TO : All Bidders
FROM : El Monte Union High School District
BID # : 2024-25 (B5)
PROJECT : Rosemead Adult Education and Transition Center Addition/Modernization REBID
SUBJECT : Addendum No. 2

ADDENDUM 04

Rosemead Adult Education and Transition Center

DSA Application No: 03-122743

**FINISH PLAN -
LEVEL 2**

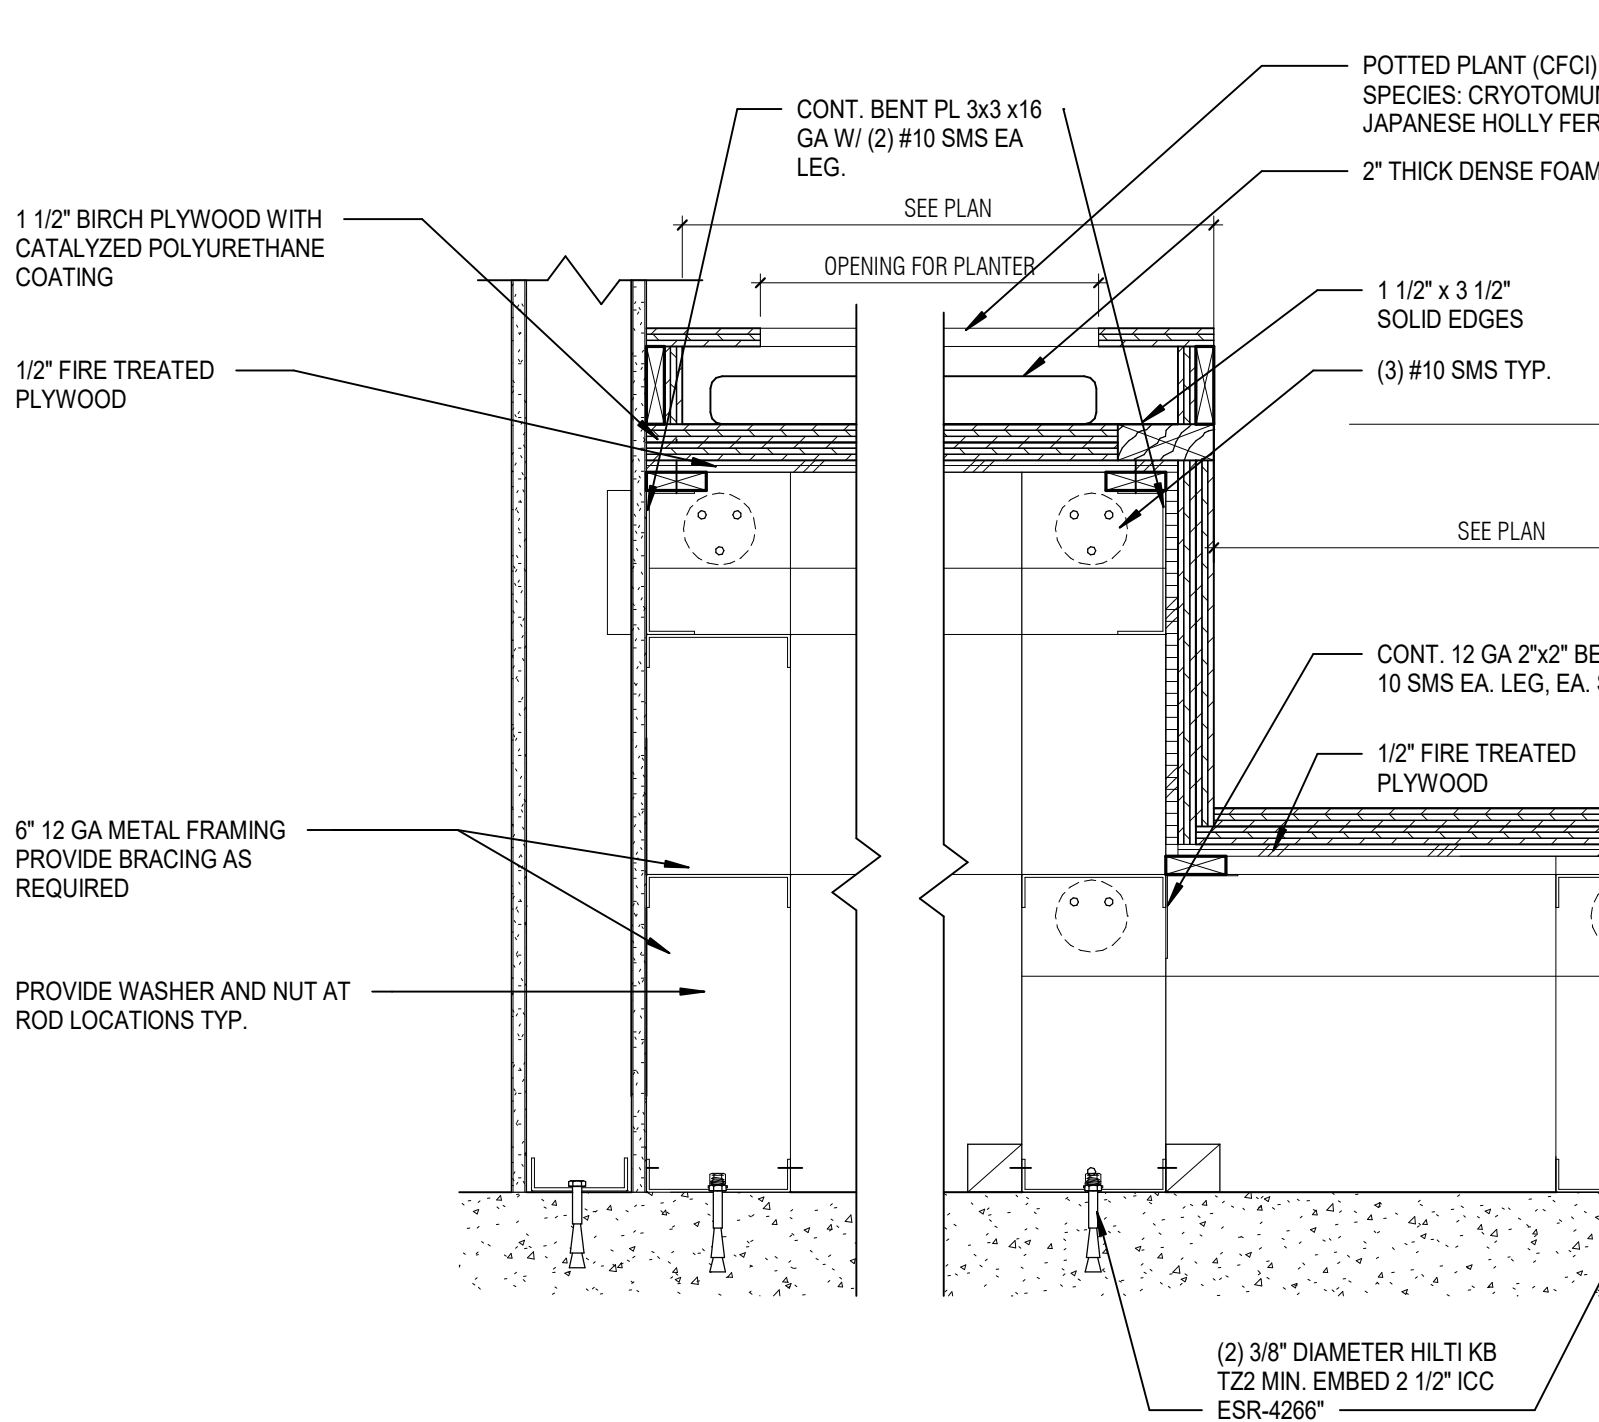
Answer *All railings are to be painted, UNO.*
- RFI 139** In Front End Document Exhibit B, the Addendum 2 drawing A12.1 indicates flooring type RF-2 is not used. On drawing A13.A flooring type RF-2 is called out in room B-101 and on drawing A13.B in room A-205. Please clarify what flooring type is required at rooms B-101 and A-205.

A. Revised floor finish tag at A-205.

Answer *RF-1 is required at these rooms. See revised finish plans A13.A and A13.B.*
- RFI 140** Moisture vapor emission control is identified in two separate spec sections. In section 090561.13 - Moisture Vapor Emission Control, paragraph 1.2.A.1 indicates to install at all ground level concrete to receive new flooring finish. In section 033000 - Cast-In-Place Concrete, paragraph 2.01G indicates to install at elevated slabs and slabs on grade. Please clarify which system is required.

14 ISLAND COUNTER WITH OPEN CUBBY

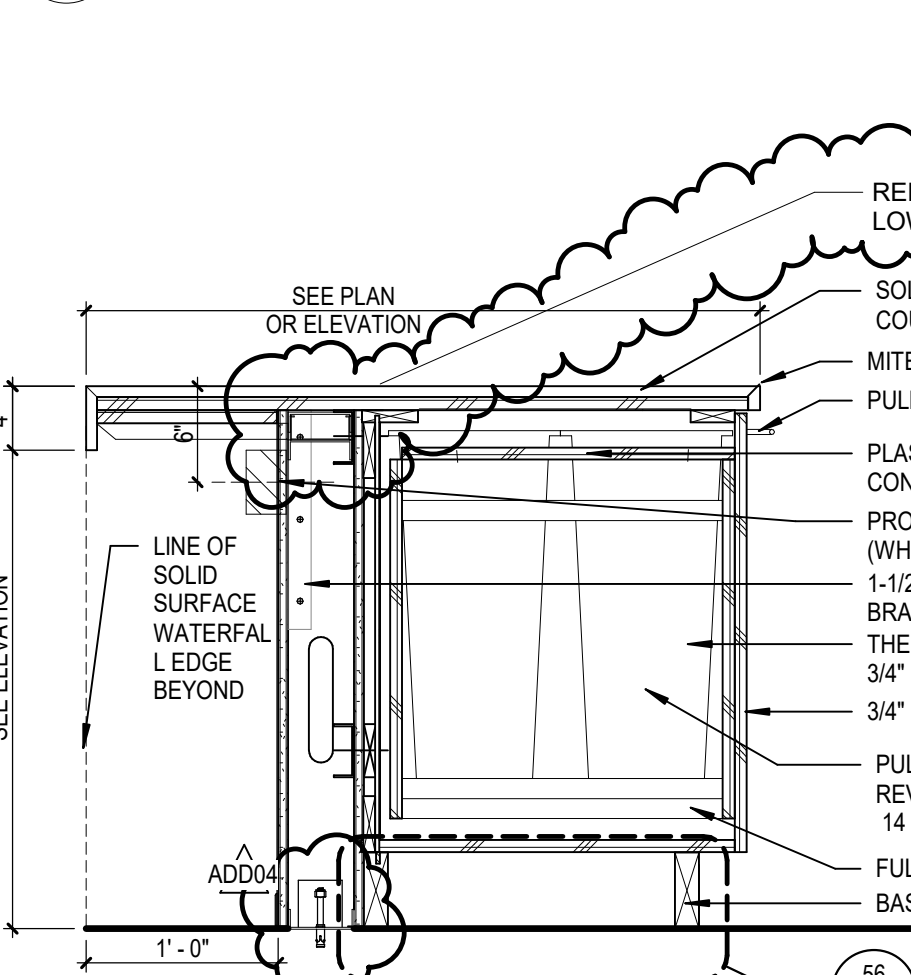
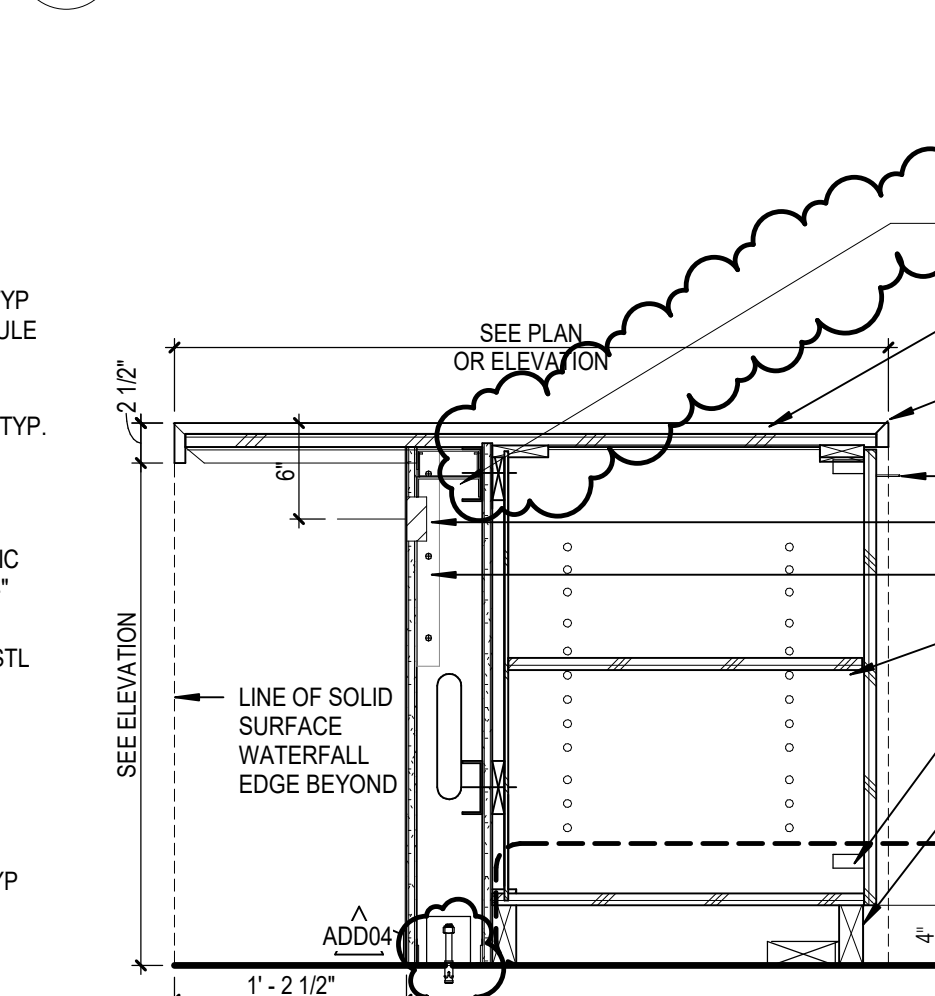
RFI 168.....Reference 2A/A11.11 and similar. The type of framing at the freestanding desks and island counters per 54 & 56/A14.6 and 33 & 34/A14.6 is not clear. The details show conflicting information regarding the framing and there are no wall types shown for this framing. Will these be prefabricated with wood framing only (millwork), offsite by others? Please confirm or clarify.

A. Revised details 14, 24, 33, 34, 54 and 56/A14.6.

Answer.....*Reference revised details 33, 34, 54 & 56/A14.6 for low wall framing information.*

15
S2.2 EXTERIOR WALL ELEVATION AT D.1
SCALE: 1/8" = 1'-0"

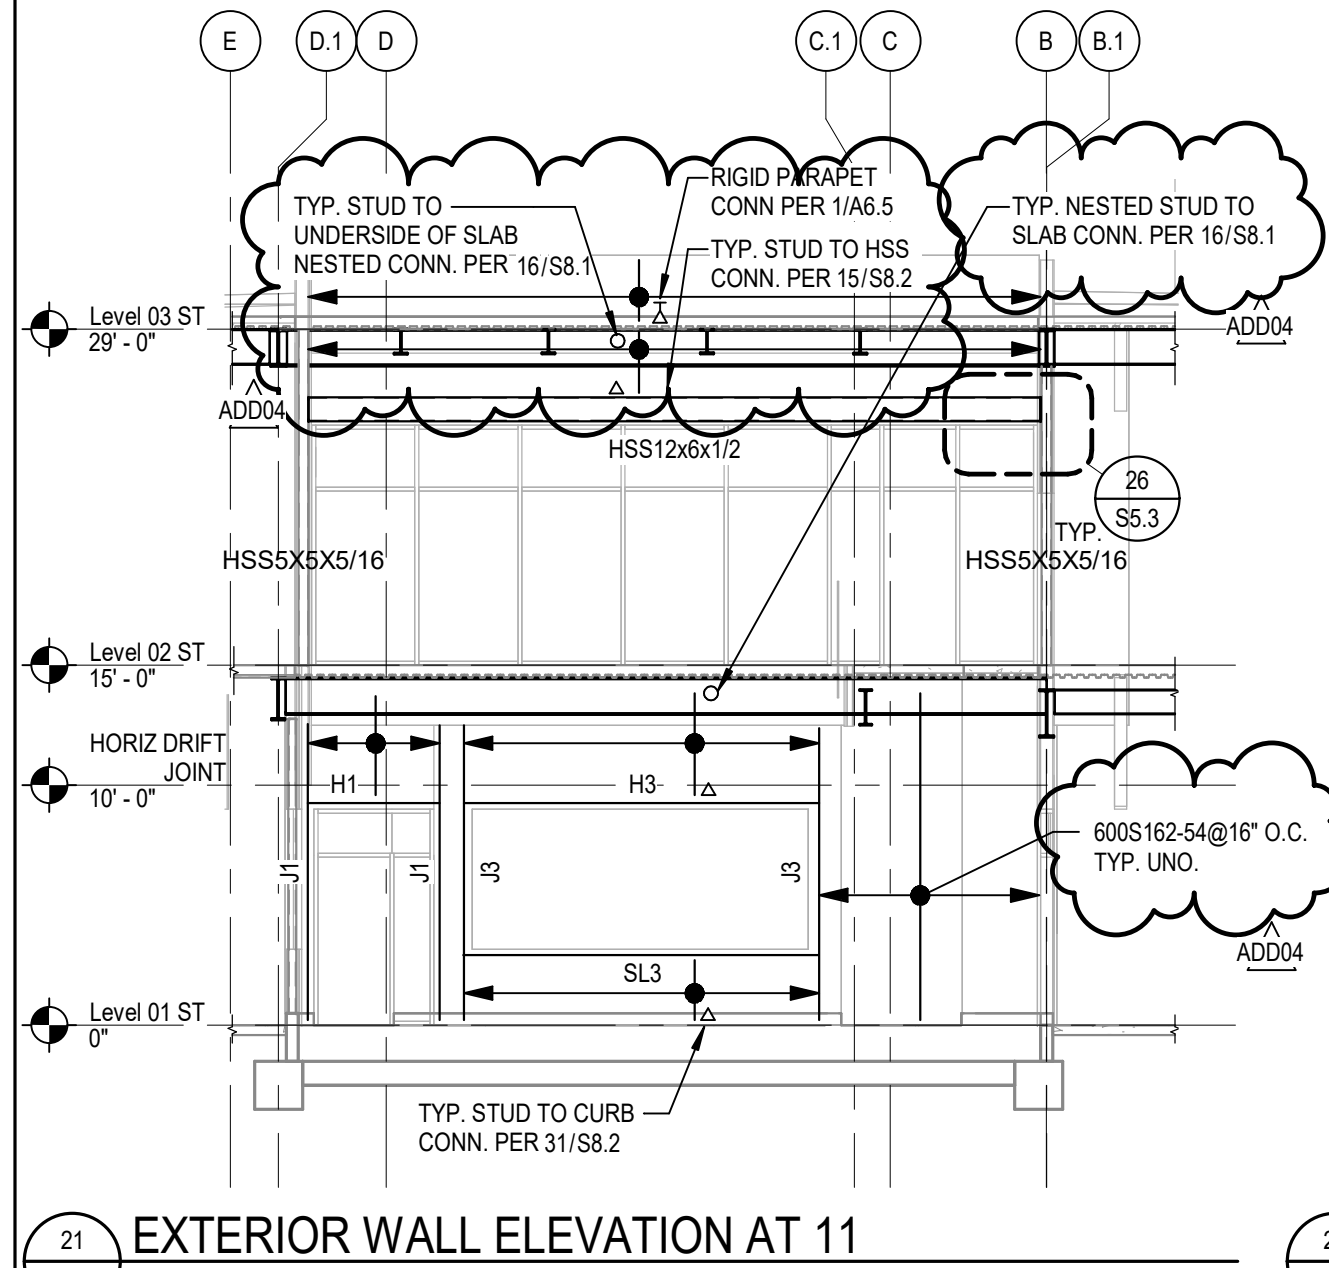
A. Detail 15 background updated to align with annotations.

21
S2.2 EXTERIOR WALL ELEVATION AT 11
SCALE: 1/8" = 1'-0"

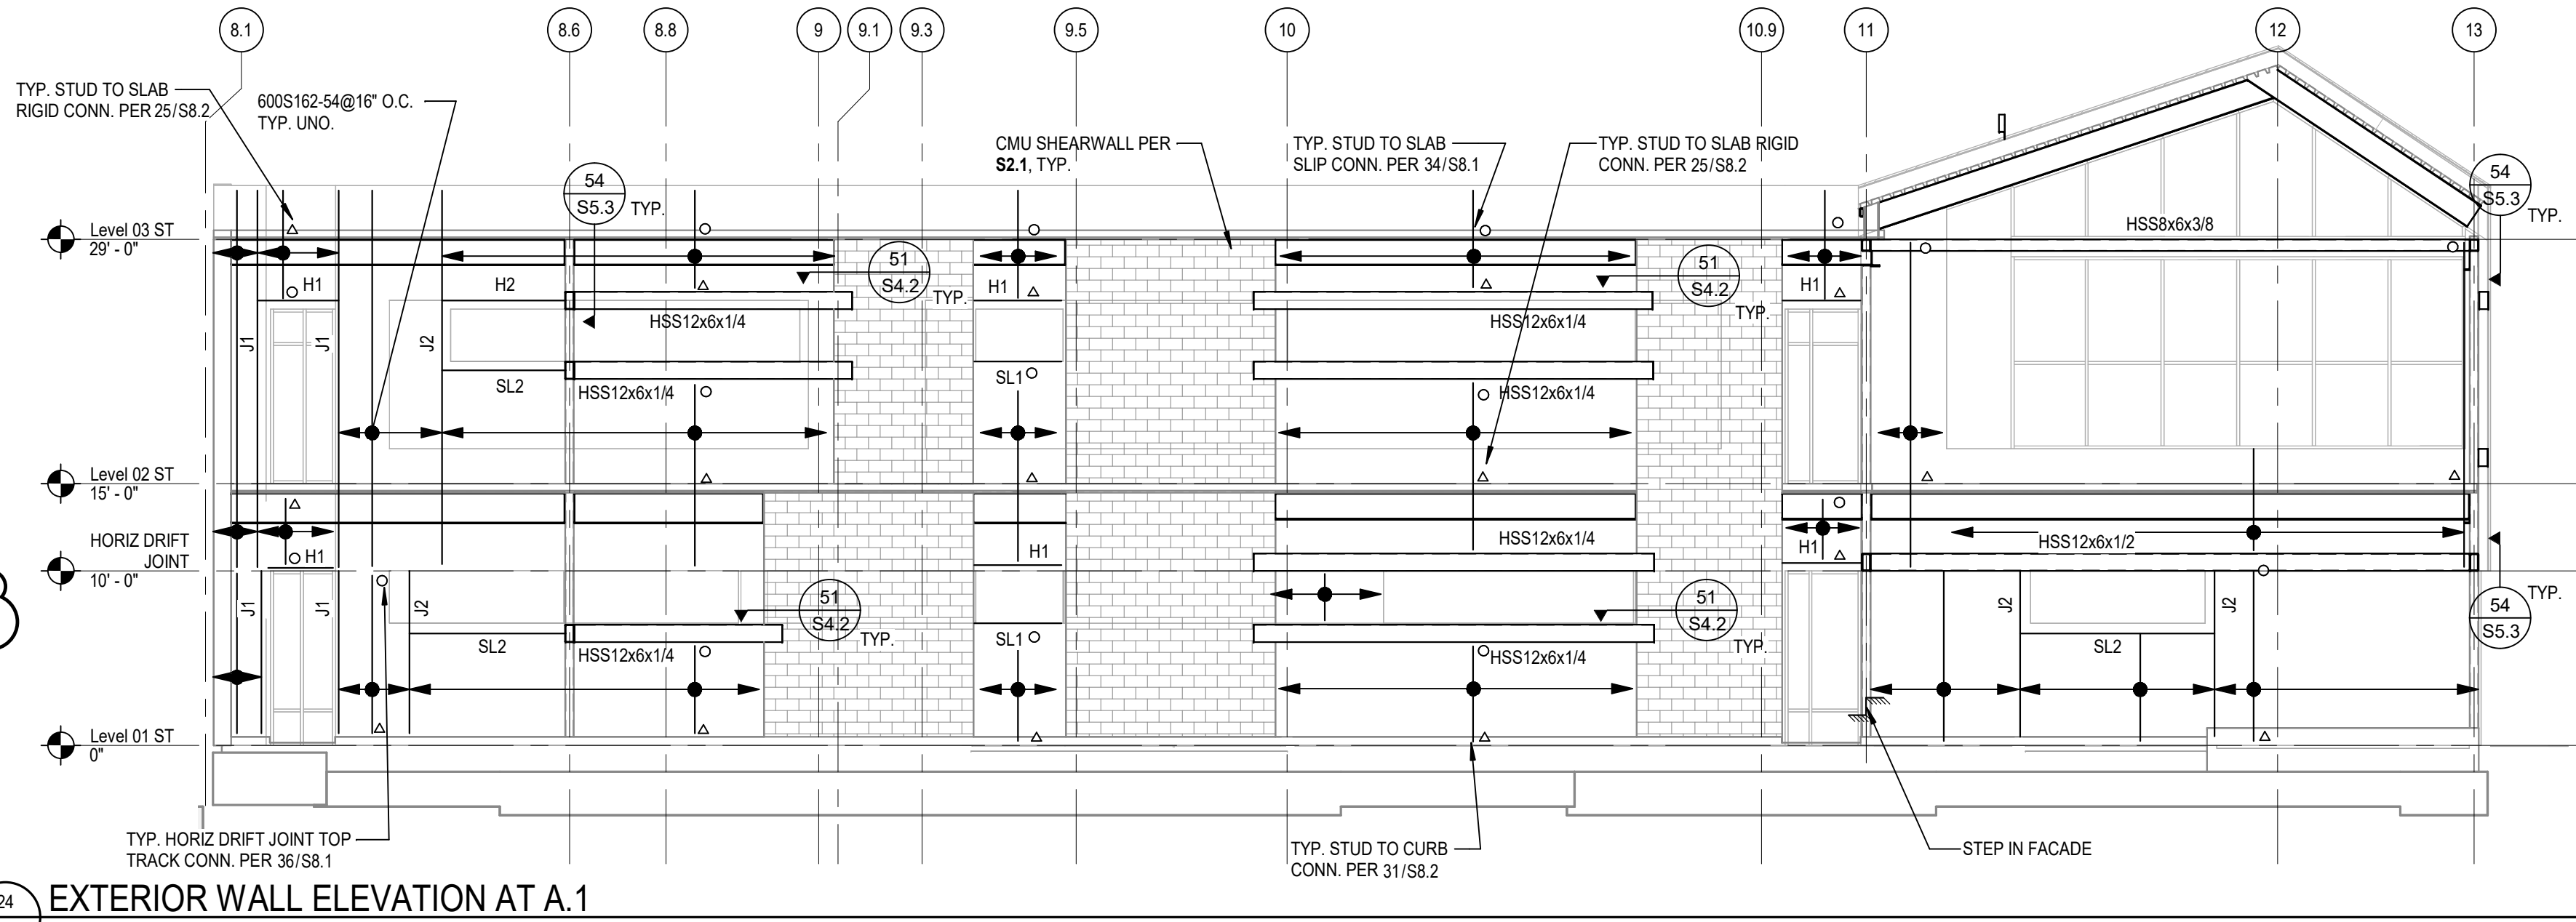
B. Detail 21 Stud callout made 600S162-54 (no change to stud size, only callout clarified).

C. Detail 21 Studs at Level 03 broken to reflect extended slab edge.

D. Detail 21 Connections for studs near level 03 updated to reflect extended slab edge condition.
